DATE ~~R~~ Oct.21/02**V2500-A1/A5/D5 PROPULSION SYSTEMS SERVICE BULLETIN**

This document transmits Revision 1 to Service Bulletin EV2500-72-0282

ENGINE – PROVIDE NEW FRONT AND REAR NO. 4 BEARING FACE SEALS1. Planning InformationA. Effectivity

No. 4 bearing front seal assembly
Fig 1

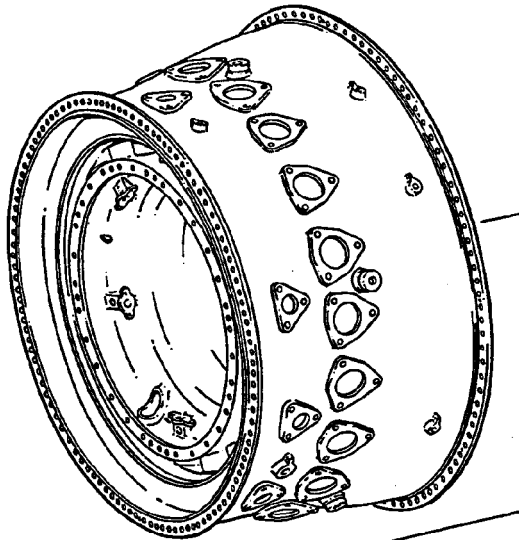
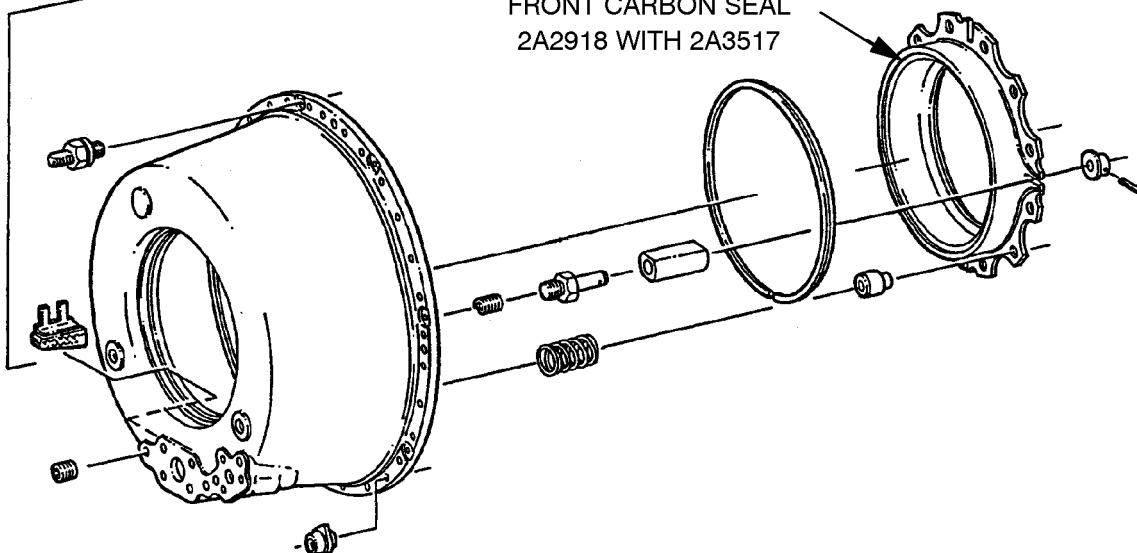
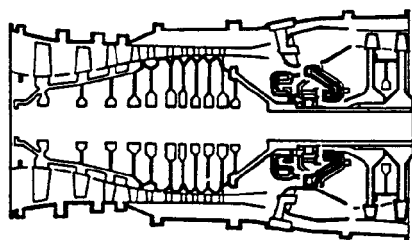
- (1) Disassemble the No. 4 Front Seal Assembly by the approved procedures in reference (5) or (6), Chapter/Section task 72-42-33-040-001.
 - (a) Replace the Carbon Seal Assembly PN, 2A2918 with PN, 2A3517.

REPLACE NO. 4 BEARING
FRONT CARBON SEAL
2A2918 WITH 2A3517

- (b) Assemble the No. 4 Front Seal Assembly by the approved procedures in reference (5) or (6), Chapter/Section task 72-42-33-440-001.
 - (c) After modification identify the No. 4 Front Seal Assembly PN, 2A2930 as PN, 2A3535 by the approved procedure in reference (7) Chapter/Section 70-09-00.

No. 4 bearing rear seal assembly
Fig 2

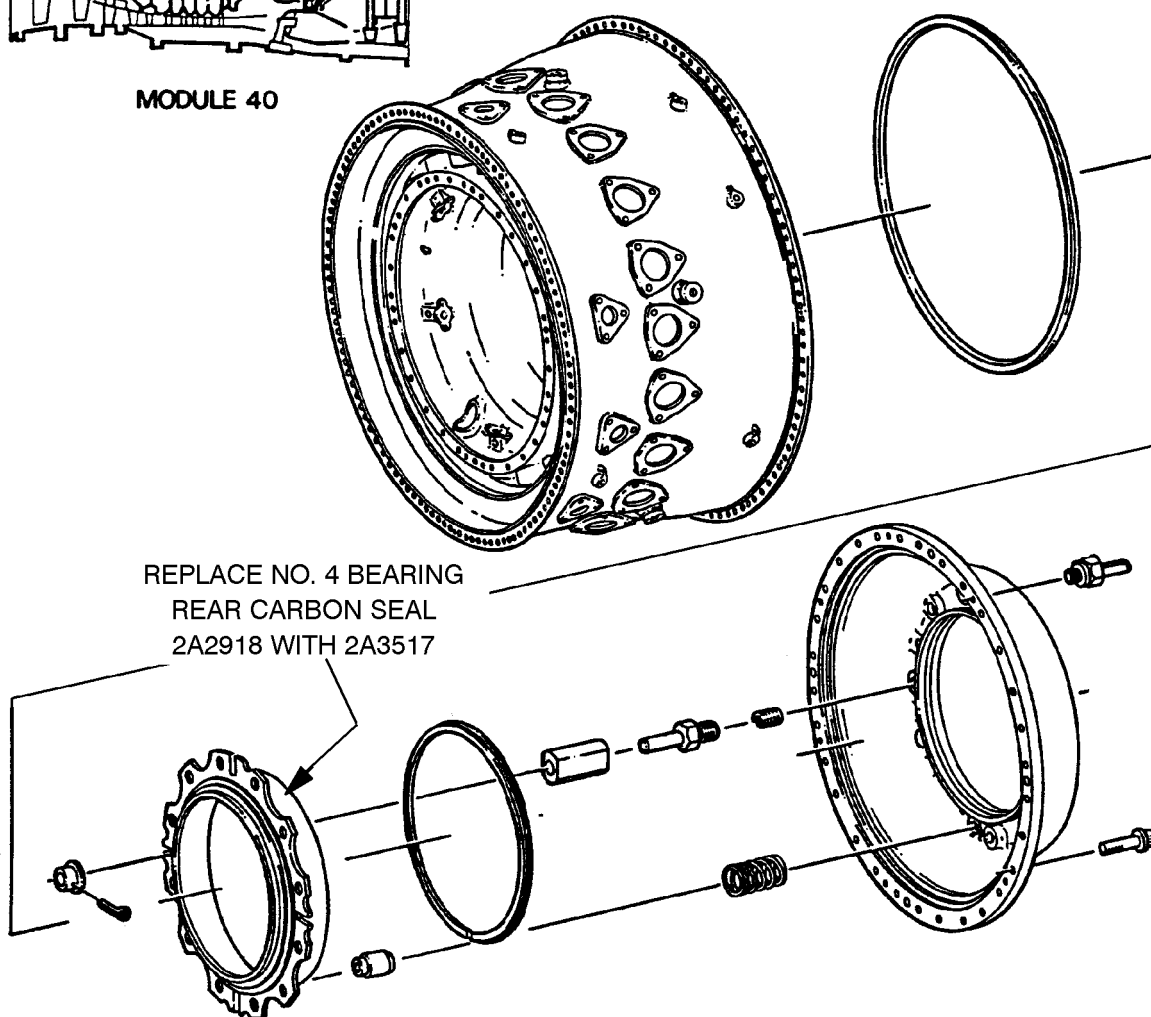
- (2) Disassemble the No. 4 Rear Seal Assembly by the approved procedures in reference (5) or (6), chapter/section task 72-43-20-040-001.
 - (a) Replace the Carbon Seal Assembly PN, 2A2918 with PN, 2A3517.

- (b) Assemble the No. 4 Rear Seal Assembly by the approved procedures in reference (5) or (6), Chapter/Section task 72-43-20-440-001.
 - (c) After modification identify the No. 4 Rear Seal Assembly PN, 2A2931 as PN, 2A3526 by the approved procedure in reference (7) Chapter/Section 70-09-00.
